SERVICE NOTES

B&W MODEL 5100 TRANSMITTER

### MODIFICATION TO REDUCE BACKWAVE

## ADDENDA SHEET #1

# FILTER NETWORK

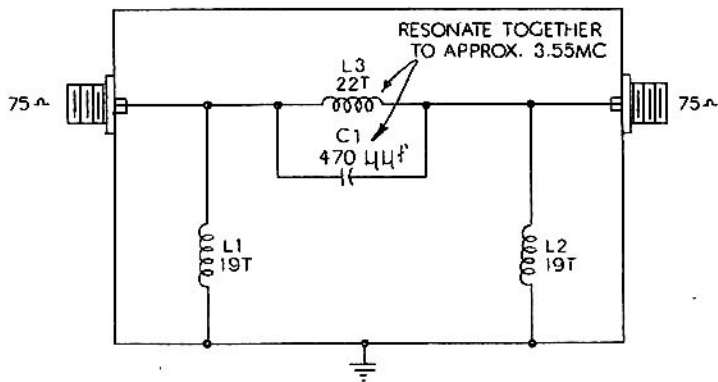
An adequate means of correcting the 40 meter sub-harmonic in troublesome cases, is the use of a High Pass Filter connected in series with the output of the transmitter.

A circuit diagram of an easily constructed and effective High Pass Filter is attached. It is understood that this filter must be removed from the feed line circuit when operating on 80 meters, but it may be left in the circuit when operating on any of the other bands. Its use will provide at least 25 D.B. attenuation of the 40 meter sub-harmonic.

- 1 ALL COILS ARE MODIFIED #3011 MININDUCTORS
- 2 CAPACITOR IS 2500V, TRANSMITTING TYPE
- 3 FOR BEST RESULTS, ASSEMBLY SHOULD BE SHIELDED
- 4 MAY BE LEFT IN TRANSMISSION LINE FOR ALL BANDS EXCEPT 80 METERS

PARTIAL WIRING DIAGRAM  
BUFFER-XTAL OSC.

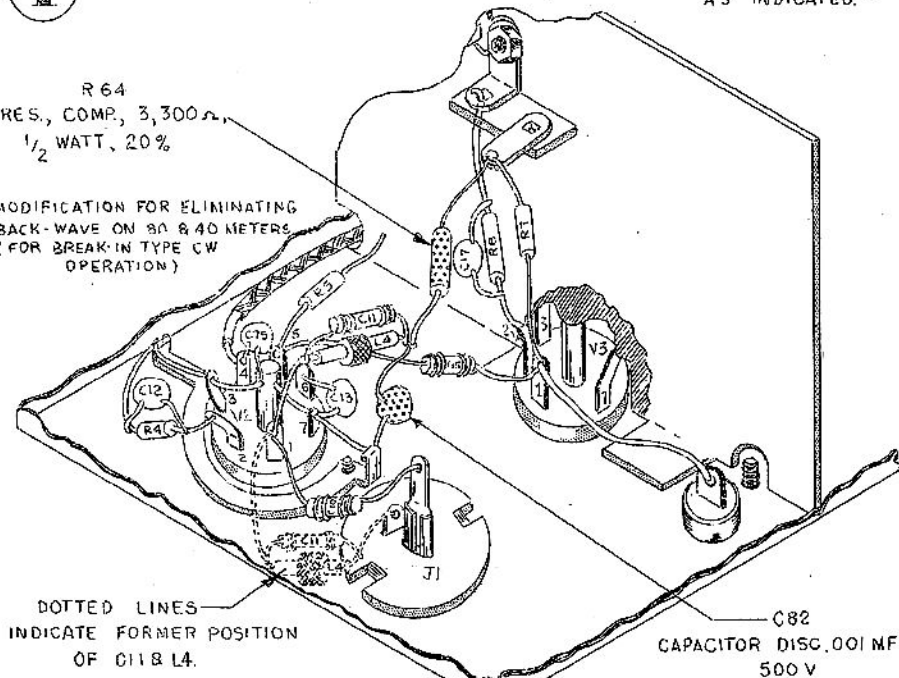
R64 & C82 TO BE ADDED  
CHANGE POSITION OF C11 & L4  
AS INDICATED.

DOTTED LINES  
INDICATE FORMER POSITION  
OF C11 & L4.

1. Remove the "Buffer-Xtal Osc." Unit from the Transmitter.
2. Remove bottom shield from the unit by removing the six screws on the sides.
3. Referring to the accompanying drawing, disconnect the parallel combination of L4 and C11 from the ground lug of J1, and connect and solder to junction of R64 and C82 as shown.
4. Connect and solder other end of C82 to ground lug as shown.
5. Connect and solder R64 and R7 as shown.

R64  
RES., COMP, 3,300  $\Omega$ ,  
 $\frac{1}{2}$  WATT, 20%

C82  
CAPACITOR DISC. 001 MF  
500 V

## ② BIAS MODIFICATION

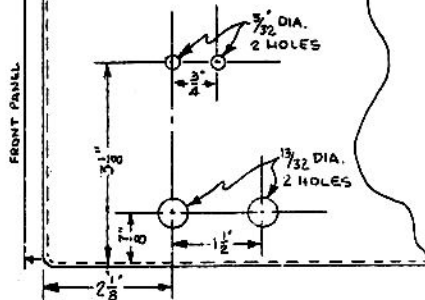
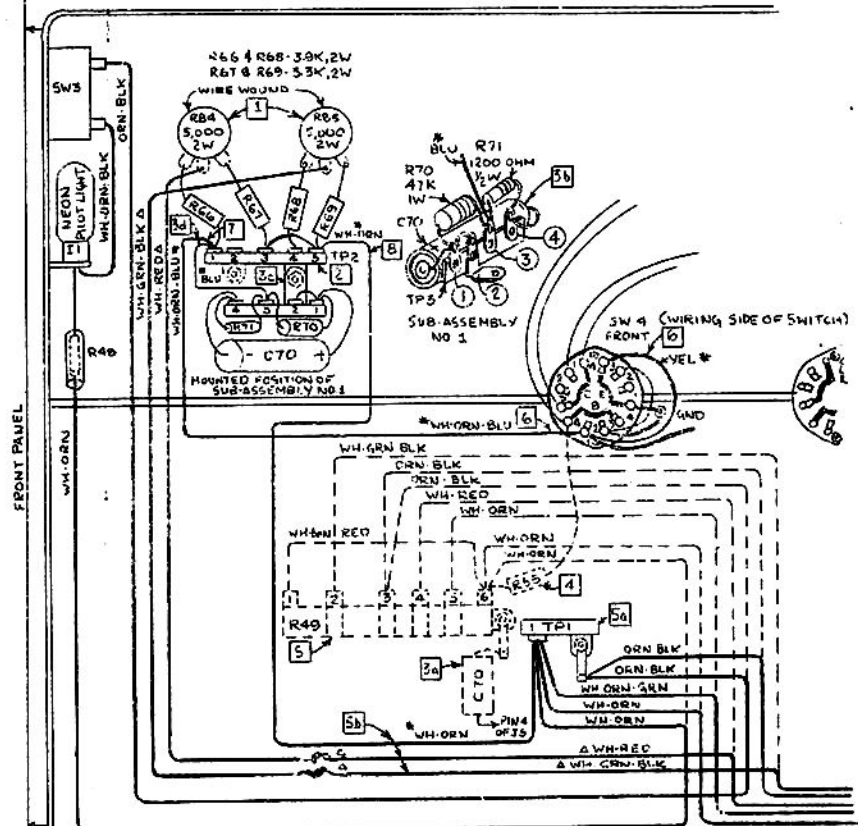
1. W- INDICATES 4 ADDITIONAL WIRES (WH-OR, WH-ORN, BLU, BLU #VEL)
2. A- INDICATES EXISTING WIRES WHICH ARE TO BE SPLICED FOR ADDITIONAL LENGTH (WH-RED & WH-GRN-BLK)
3. DASHED LINES (---) INDICATE FORMER ARRANGEMENT, SOLID LINES & HEAVY CONNECTIONS (—) SHOW MODIFICATION.

1. Place two 5,000 ohm pots. (R84 & R85) in 13/32" dia. holes, and secure in place.
2. Place five terminal tie point (TP2) in 5/32" dia. holes. Tighten the nut nearest the front panel, leave other nut loose for mounting of sub assembly #1. At this point connect and solder resistors R66, R67, R68, and R69 as shown, also connect jumper wire between 3 and 5 of TP2.

3. Prepare Sub Assembly #1
  - a. Carefully remove C70 from terminal 4, of J5 (12 pin Jones Conn.) and ground lug on mounting screws (nearest back of chassis) of R49.

- b. Prepare Sub-Assembly #1 by using 4 terminal tie point (TP3) and two resistors (R71 & R70), and C70 (removed in (a) ). Connect these items as shown by attached drawing. (Observe polarity on C70). Also connect jumper between terminals 1 and 2 of TP3, and attach 2" Blue lead to Terminal 3 of TP3.

- c. After completing sub-assembly #1 attach the entire sub-assembly to TP2 by means of mounting tab on TP3. Tighten nut to secure position.
  - d. At this time connect other end of 2" Blue lead to Terminal 1 of TP2.

4. Delete resistor (R55) which is connected from SW4 Section B Terminal 4, and terminal 6 of R49 (end towards back of chassis).
5. Delete R49 by unsoldering all wires, and removing mounting screws.

- a. The one terminal tie point (TP1) is then mounted in mounting hole of R49 (one nearest back of chassis). Place solder lug over mounting screw before securing into place.

- b. Connect wires removed from R49 to TP1 as shown by attached dwg. Two leads (Wh-Red & Wh-Grn-Blk) are to have additional lengths added. (Be sure to tape wires securely after splicing). One 12" (Wh-Orn) lead is added at this point.

6. Remove switch SW4 from its bracket, and solder jumper wire (yellow) between Contact 1 of Section B and Contact 3 of Section E. Also solder a 12" (Wh-Orn-Blu) lead to contact 1 of Section B. Place switch back in its brackets and secure.

7. Connect other end of (Wh-Orn-Blu) lead used in step 6 to terminal 1 of TP2.
8. Connect other end of (Wh-Orn) lead used in step 5 (b) to terminal 5 of TP2.
9. After you have checked with the drawing to see that all connections are correctly made, dress wires into cable.
10. Replace Multiplier Unit and all Tubes.
11. Make sure that the bias potentiometers are in the extreme counter-clockwise (maximum bias) position before application of plate voltage.

# B&W MODEL 5100 TRANSMITTER CIRCUIT CHANGES

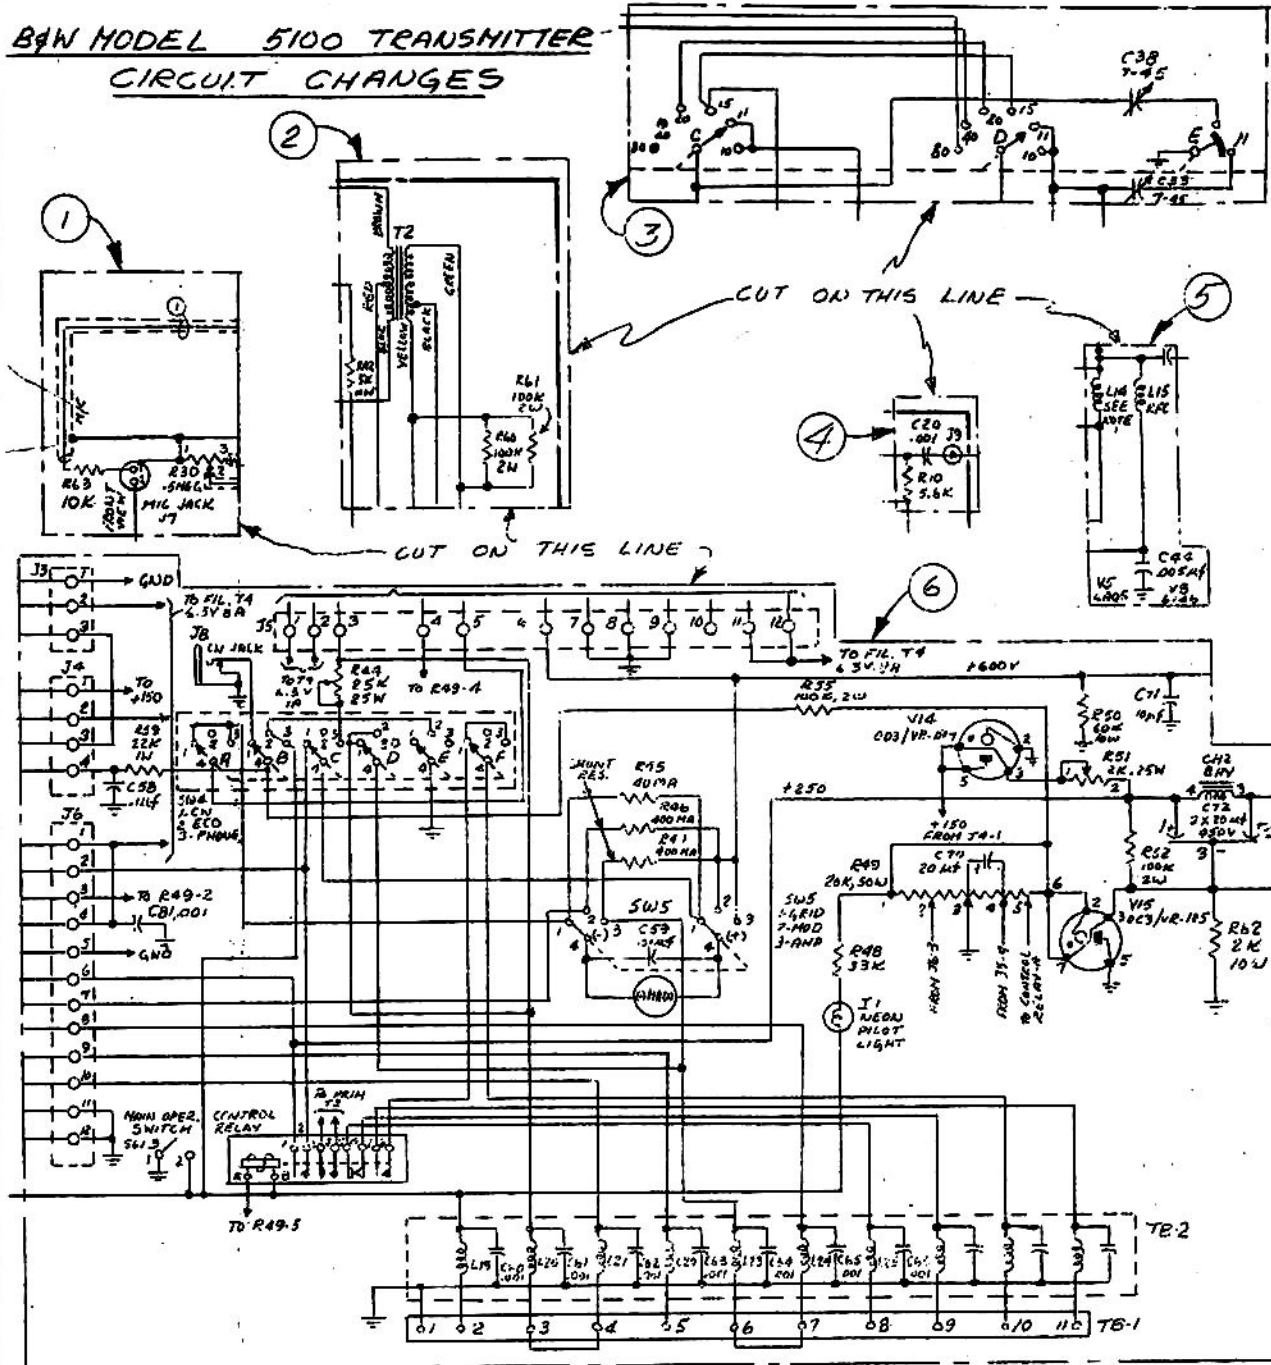
NOTE:  
THESE CORRECTED CIRCUITS HAVE BEEN DRAWN TO SCALE, CUT OUT AS SHOWN AND PASTE ON INSTRUCTION MANUAL SCHEMATIC IN PROPER PLACES AS INDICATED BY CIRCLED NUMBERS (1)(2)(3)(4)(5)(6).

- PLACE MENT
- ① - MODULATOR (CIRCUIT OUTSIDE OF HEAVY LINE)
  - ② - MODULATOR (UPPER RIGHT HAND CORNER)
  - ③ - MULTIPLIER - FINAL AMP. (TOP CORNER OF SW)
  - ④ - BUFFER - XTAL OSCILLATOR (UPPER RIGHT)
  - ⑤ - MULTIPLIER - FINAL AMP. (LOWER RIGHT, ABOVE PH)
  - ⑥ - POWER SUPPLY

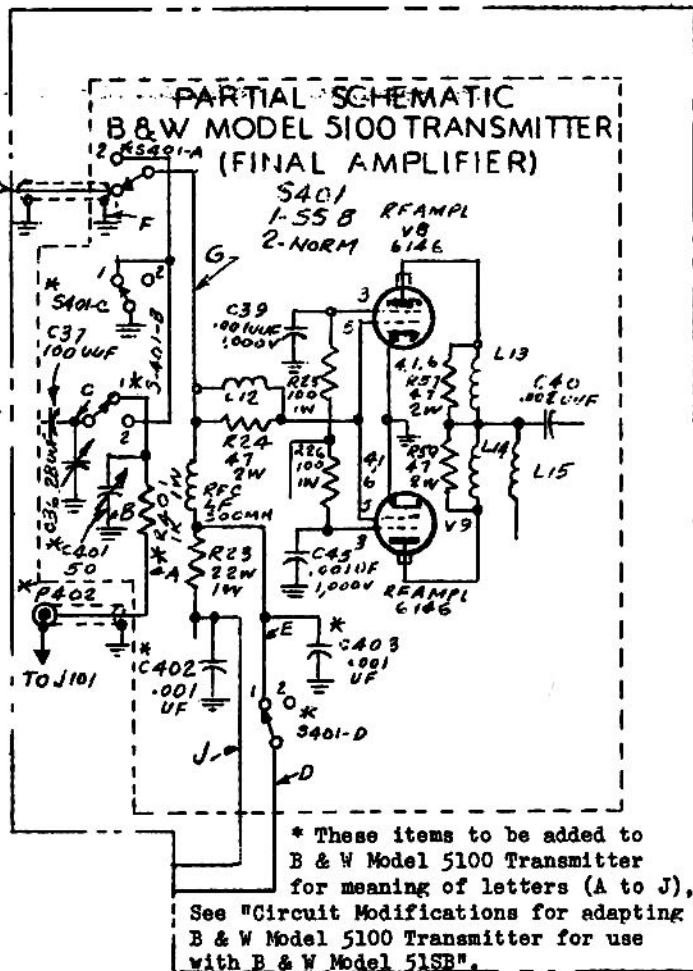
2. Remove all tubes from the Multiplier-Final Amplifier Unit.
3. Before making any changes, study the layout at the rear of the unit and compare with the accompanying modification drawing. Note that no parts are removed from the unit in the modification. We do however, add a switch and bracket assembly, three capacitors, one resistor, and the necessary hardware, wires, and cables. When properly wired, the function of the switch in the "SSB" position is to connect the RF output of the multiplier section to the RF input of the Model 515B, and at the same time, connect the RF output of the Model 515B to the grids of the RF power amplifier. It also provides for metering the grid current of the power amplifier tubes by means of the meter on the Model 515B. Placing the switch in the "Norm" position restores the Model 5100 Transmitter to normal operation for conventional AM telephony or CW.

4. Delete spaghetti covered wire connecting excitation control C36 to R24. (This is the wire passing through prommet [5], and is deleted in drawing.)
5. Remove switch nut and washers, [1], and mount terminal strip, item [3], with two shakeproof washers, item [1], and  $\frac{1}{2}$  x 5-40 nut, item [2], while holding switch bolt from inside of chassis to prevent bolt from turning.

6. Remove switch nut and washers, [2], and mount lockwasher type solder lug, item [4], with the  $\frac{1}{2}$  x 5-40 nut, item [2], while holding switch bolt from inside of chassis to prevent bolt from turning.

7. Fasten solder lug and lockwasher, items [5] and [6], under screw [3].
8. Solder jumper wires between switch contacts as shown on detail of switch wafer.

9. Remove top screw, [5], from chassis; attach switch and bracket assembly, item [7], to chassis by means of screw, [5], and lockwasher, item [6].
10. Drill hole ( $7/64$ " dia. or #35 drill) through chassis, using mounting hole in switch bracket as template. Before drilling hole, make sure that top edge of bracket is parallel to top edge of chassis.

11. Add screw, item [8], and lockwasher, item [6], to secure switch bracket to chassis.
12. Solder capacitor, C403, item [14] to switch contact, solder lug, and terminal strip as shown in note 2 and drawing.

13. Fasten solder lug, item [5], under nut [4].

14. Solder green lead "G" between switch contact and terminal strip as shown. (Make lead short as possible.)
15. Solder White-Green lead, "E", between switch contact and terminal strip as shown. (Make lead short as possible.)

16. Solder shielded input cable assembly, item ⑪, to terminal strip, item ③, and solder lug, item ④, as shown.
17. Solder R401 and C401, items ⑨ and ⑩, between switch contact, terminal strip, items ③, and solder lug, item ④, as shown.

18. Remove screw ⑧ from chassis (shown deleted on drawing), and solder violet lead, "C", to switch contact and excitation control C36, passing wire through hole left by removing screw ⑧. (DO NOT pass this wire through the grommet hole ⑥.)

19. Solder meter cable assembly, item ⑫, to switch (White-Green) and terminal strip (Green) as shown.
20. Solder capacitor, C402, item ⑭, between terminal strip and solder lug, item ⑤, as shown.

21. Solder output cable, item ⑬, to switch and ground lug of V9 as shown.
22. Fasten cable clamp, item ⑮, over cables, item ⑪ and ⑫, by means of screw ⑦ and lockwasher, item ⑥, as shown.

**CIRCUIT MODIFICATIONS FOR ADAPTING E&W MODEL 5100 TRANSMITTER FOR USE WITH E&W MODEL 5100 SINGLE SIDEBAND GENERATOR (SEE INSTRUCTION SHEET FOR PROCEDURE)**

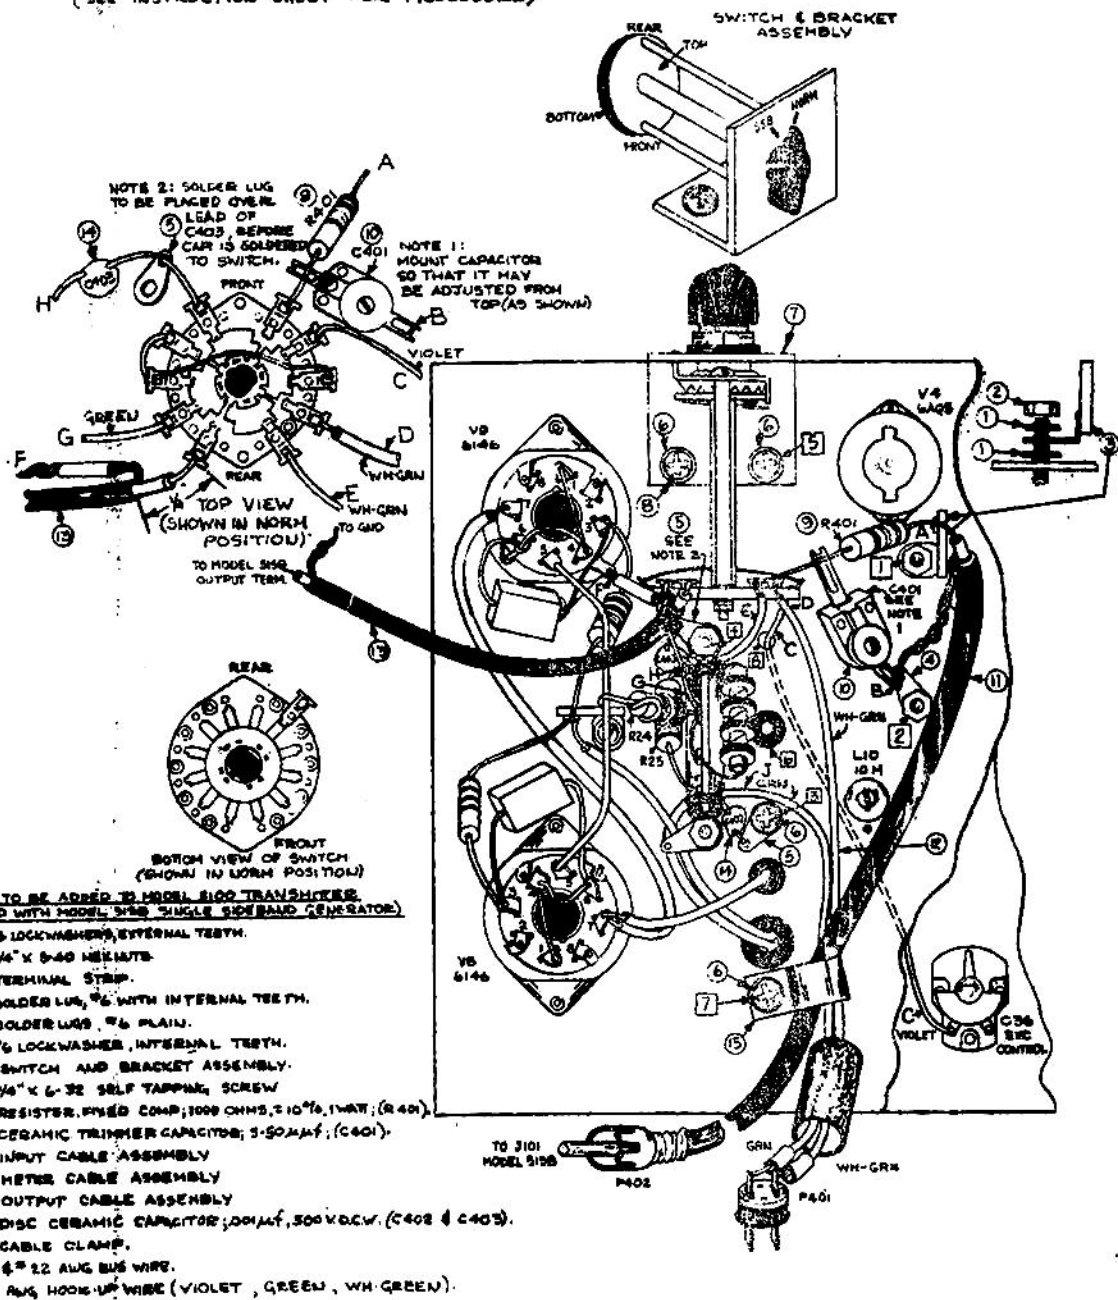
CUT SCHEMATIC ALONG  
OUTSIDE LINE

PASTE OVER SAME SECTION  
ON INSTRUCTION BOOK  
SCHEMATIC.
